Product Change Notice (PCN)

PCN Number: **PCN-0454915-01**

Product(s) Affected: **PJ-096H**

<p>Recommended PCB Layout Top View</p>	 <p>Recommended PCB Layout Top View</p>

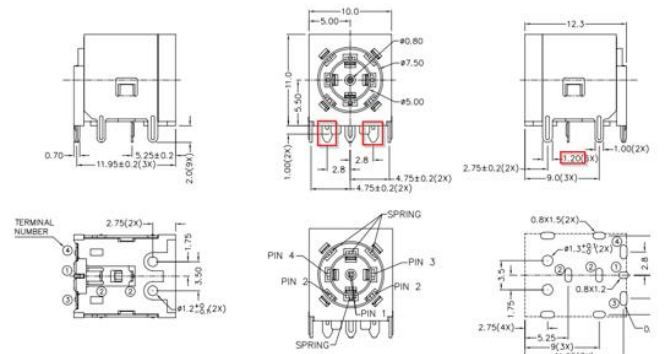
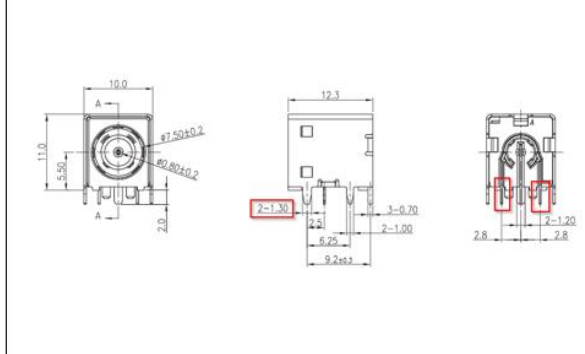
Description of Change: **Minor Housing and footprint differences. Material Change on the housing and terminals. See image Below**

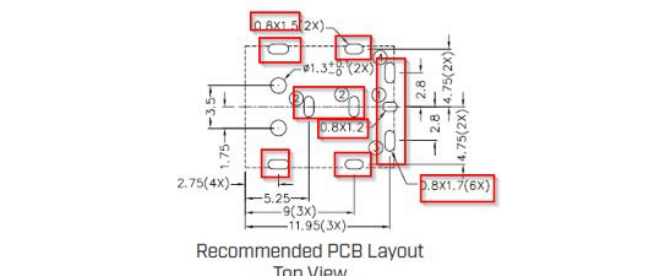
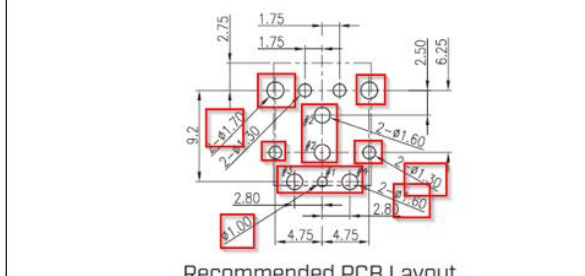
MATING PLUG
Jack Insertion Depth: **9 mm**

MATING PLUG
Jack Insertion Depth: **9.1 mm**
